P 554552

ON-SITE SEWAGE DISPOSAL SYSTEM HOWARD COUNTY HEALTH DEPARTMENT BUREAU OF ENVIRONMENTAL HEALTH

SITE PLAN FOR BAT INSTALLATION
FULTON MANOR II - LOT 3
 12305 STELLA DRIVE
 FULTON, MD 20759
 B1400116

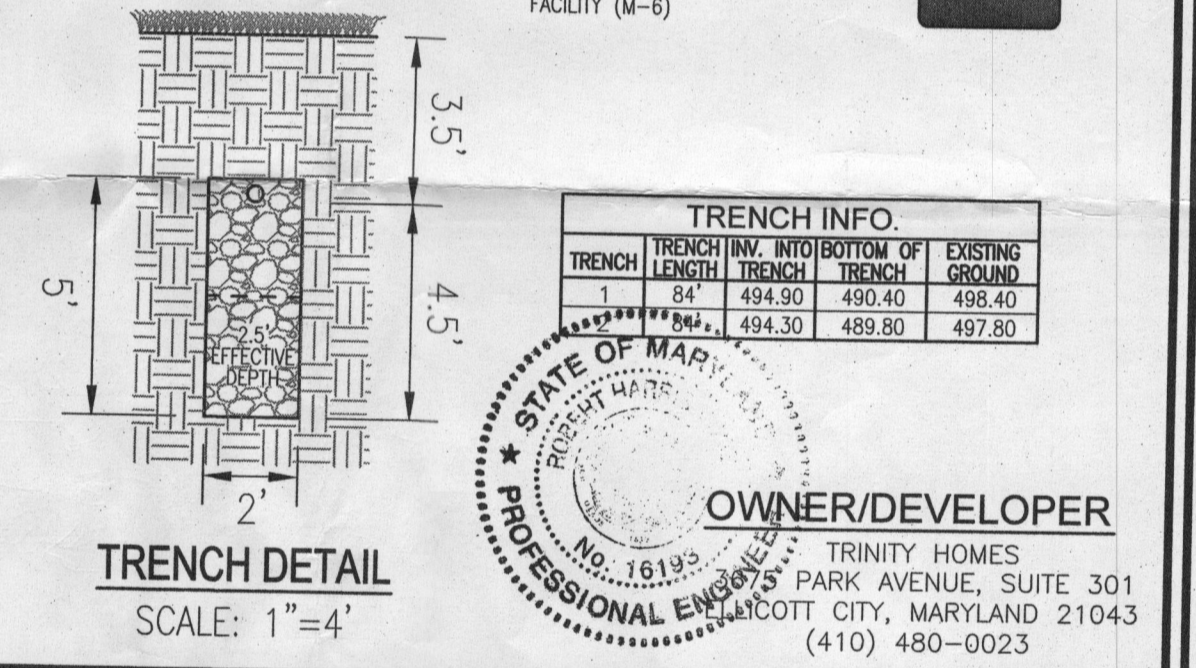
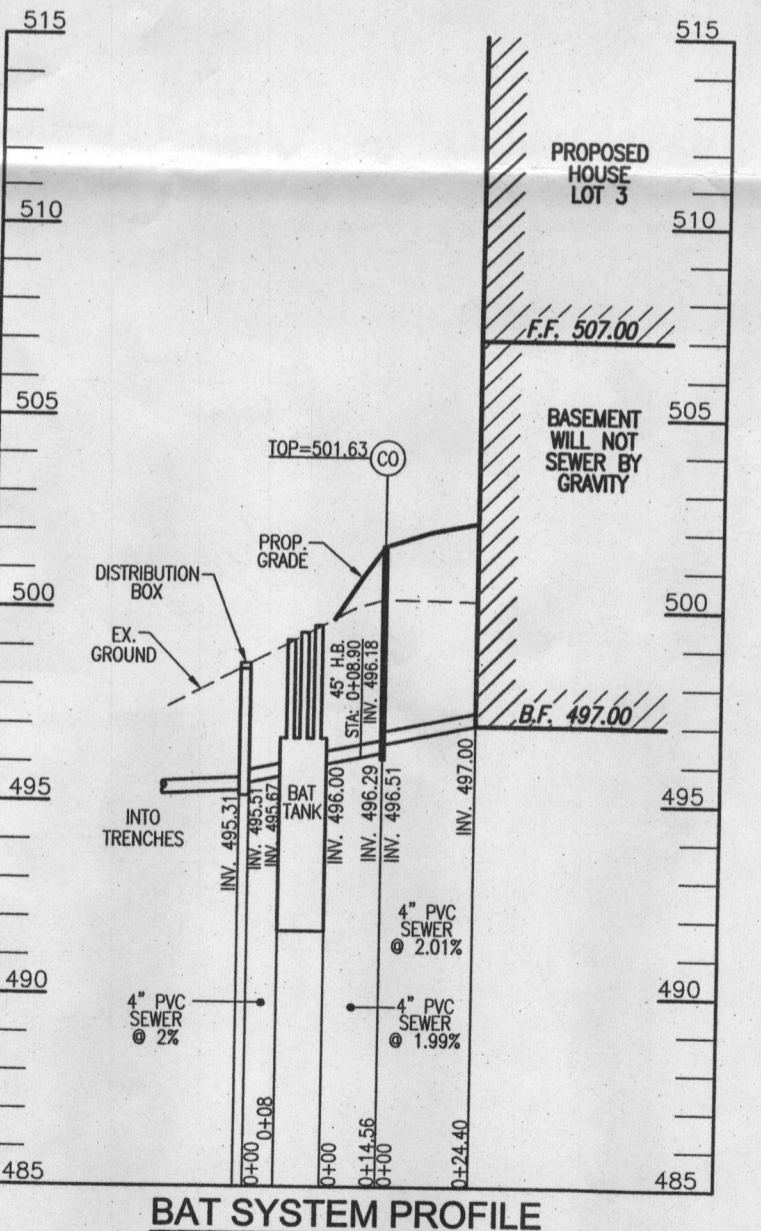
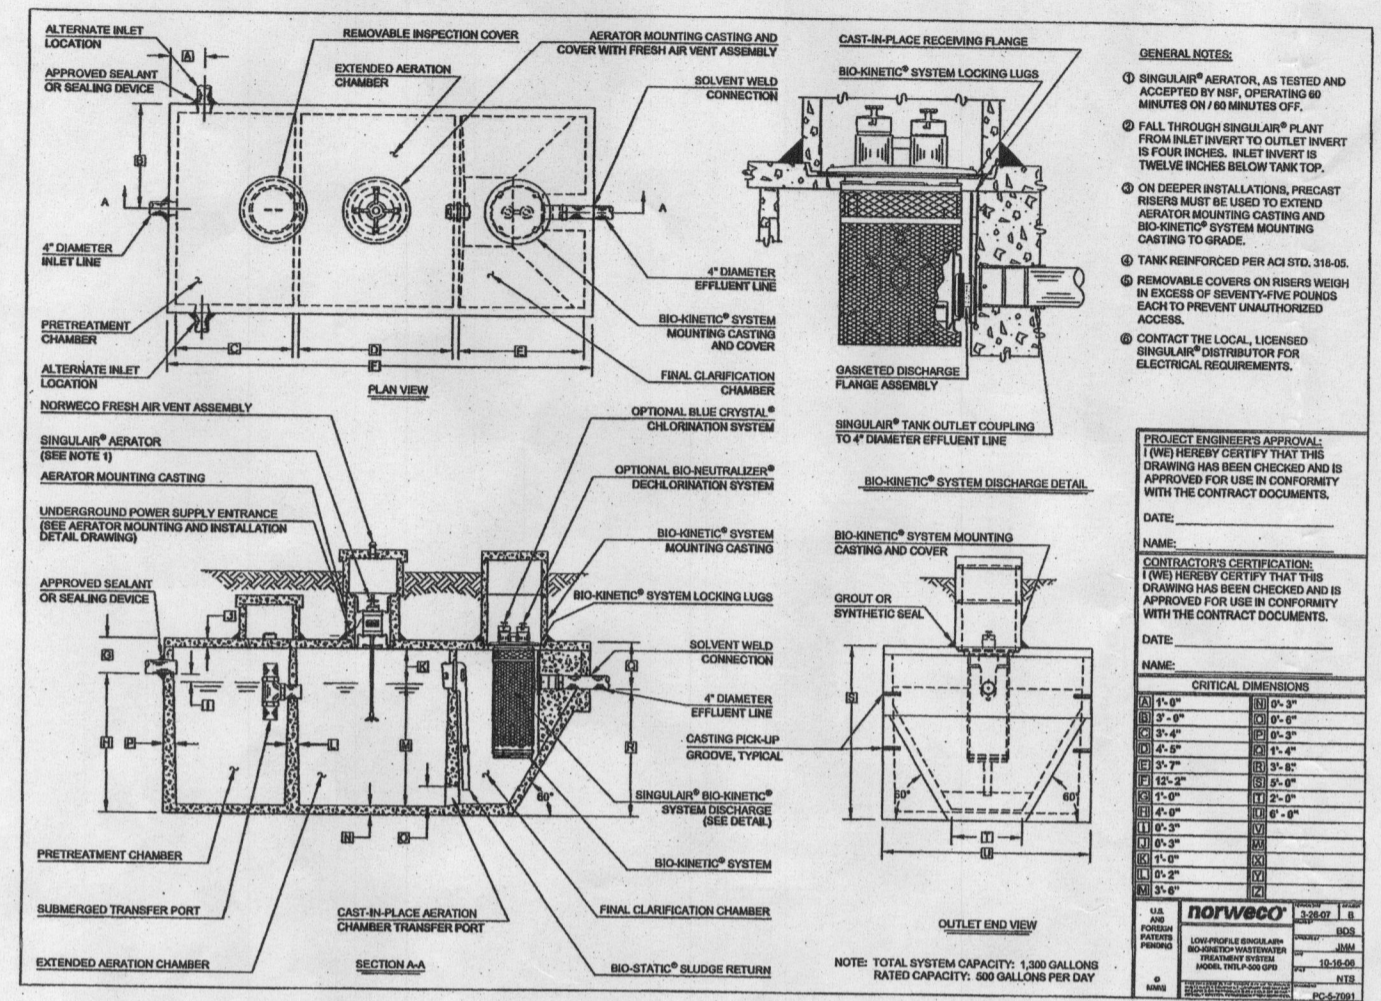
SYSTEM CALCULATIONS:
 5 BEDROOMS AT 750gpd / 1.2 ABSORPTION RATE = 625 SQ. FT.
 625 SQ. FT. / 2 (TRENCH WIDTH) x .50 (SIDEWALL REDUCTION) = 156 LINEAR FEET
 2 TRENCHES OF 84 FEET IN LENGTH ARE PROVIDED WITH THE SYSTEM FOR LOT 3.
 2x78 feet

7/23/2014 Install two 78' trenches on contour across the top of the easement. Septic tank location staked by surveyor (BB)
